**TOWN OF SHELBURNE**  
**SEWER/WATER RELOCATION (AOT WORK)**  
**PLAN AND PROFILE**  
**STA. 285+00 TO 291+00**

Shelburne NH EGC 019-4 (27)  
Sheet 467 of 537

**C-9**

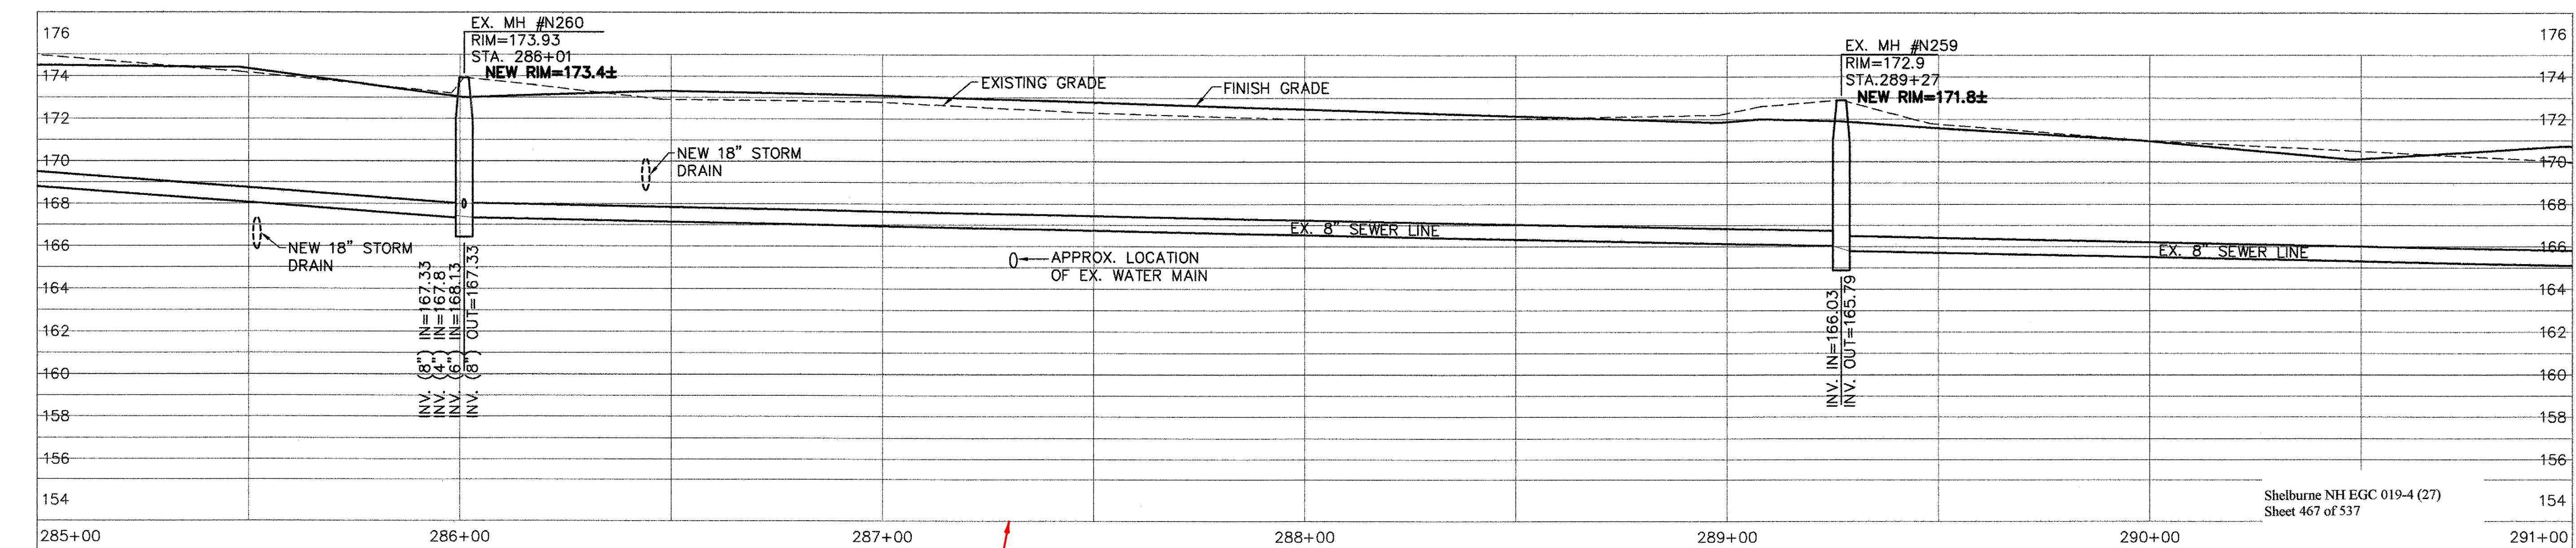
**DEPTH OF 16" SLEEVE CONSTRUCTED AT STATION 287+41 UNKNOWN. SEE PLAN FOR LOCATION OF SLEEVE.**
